COACH MODEL : T2140, T2145,& C2045

DATE : 06/01/2016

SUBJECT : New Hazard Switch Wire Instruction

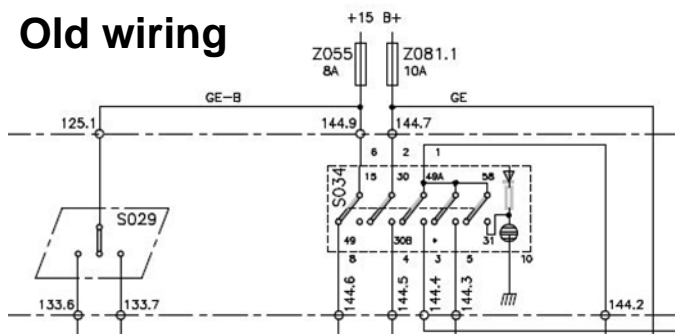
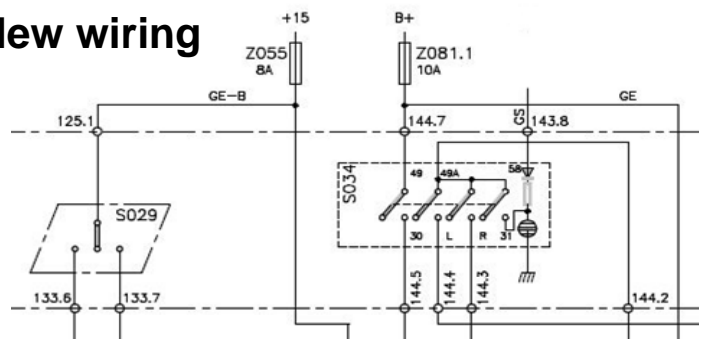
When changing switches a new plug is needed and wiring needs to be modified as shown below. Plug part number is 10753357.

Old plug wiring:

49a: Blue with Violet tracer
49: Blue with orange tracer
30b: Orange with Violet tracer
R: Violet with Yellow tracer
30: Yellow
15: Yellow with Blue tracer
L: Violet
31: Yellow with Blue tracer

New plug wiring:

49a: Blue with Violet tracer
49: Yellow
30b: Not used
R: Violet with Yellow tracer
30: Orange with Violet tracer
15: Not used
L: Violet
31: Use Spare Brown from unused dash switch light
58: Use Spare Grey from unused dash switch light

Take the "Yellow with Blue tracer wire" that was on pin 15 of old Switch, and the "Blue with orange tracer wire" that was pin 49 old switch, and butt connect them together.
